# UNITED STATES PATENT AND TRADEMARK OFFICE

APPLICATION NO.	FILING DATE	FIRST NAMED INVENTOR	ATTORNEY DOCKET NO.	CONFIRMATION NO.
10/718,836	11/21/2003	Yitzhak Zilberman	A328B-USA	1327

<b>Office Action Summary</b>	Application No. 10/718,836	Applicant(s) ZILBERMAN ET AL.	
	Examiner Terri L. Smith	Art Unit 3762

**DETAILED ACTION**

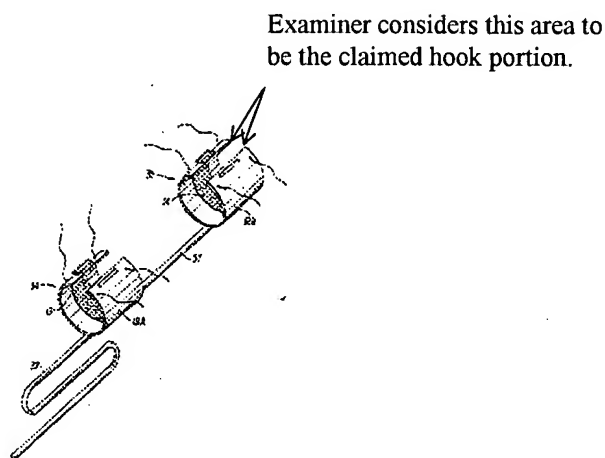
10. With respect to claims 3 and 16, at least one of the wings additionally comprises a hook portion for capturing neural/muscular tissue (claims 3 and 16) (Fig. 3 reproduced and labeled as shown below).

11. Maschino et al. disclose an implantable device is essentially tubular (13 and 14, electrical conductors, which Examiner is interpreting as the tubular implantable device) and a holder is essentially semi-circular in cross section having first and second end plates enclosing a hollow cavity in-between (Fig. 1A), wherein a holder is capable of being suitable for elastically retaining an implantable device because the holder elastically expands along its circumference and will stretch to accommodate an implantable device and because the size and dimensions of the implantable device have not been set forth (claims 4 and 17); the wings of a placement structure have inner and outer surfaces with an inner surfaces of the wings directed toward a holder (Fig. 3) and wherein a structure is suitable for retaining neural/muscular tissue in contact with electrodes of an implantable device (ABSTRACT, line 1) by providing an elastic force from the inner surfaces of the wings toward an implantable device within a holder (column 7, lines 58–62) (claims 5 and 18) and at least one of the wings includes an electrically conductive portion on its

inner surface that provides an electrically conductive path to a portion of a hollow cavity of a holder (Fig. 3), wherein at least one of the electrodes of an implantable device is capable of being electrically connected to an inner surface of at least one of the wings when an implantable device is inserted within a holder because the wings have conductive strips on the inner surface (Fig. 3) (claims 6 and 19); a conductive portion is formed to minimize eddy currents (claims 7 and 20) (Figs. 1 and 3; column 4, lines 34–36 where it is inherent that the reference current spread is, in its broadest interpretation, an eddy current because an eddy current is a current that runs contrary to the main current); a conductive portion is comb shaped (claims 8 and 21) (Figs. 4D–4E; a conductive portion is formed from serpentine paths (claims 9 and 22) (Fig. 1A; column 4, lines 32–33; column 7, lines 30–32 where Examiner is interpreting the braided or woven material to represent the serpentine paths).

12. Regarding claims 11 and 24, Maschino et al. disclose an implantable device has proximal and distal electrodes (Fig. 3, elements 13 and 14) and a placement structure comprises first and second opposing wings (Fig. 3, elements 34 and 35) and wherein a first electrically conductive path is formed between a proximal portion of a hollow cavity and a first wing (13 and 34) and a second electrically conductive path is formed between a distal portion of a hollow cavity and a second wing (14 and 35), wherein a proximal electrode of an implantable device is capable of being electrically connected to an inner portion of a first wing because the wing elastically expands and will stretch to accommodate an implantable device and because the size and dimensions of the implantable device have not been set forth and the wing has conductive strips on its inner surface (column 9, lines 3–7) and a distal electrode of an implantable device is capable of being electrically connected to an inner portion of a second wing (column 9, lines 3–
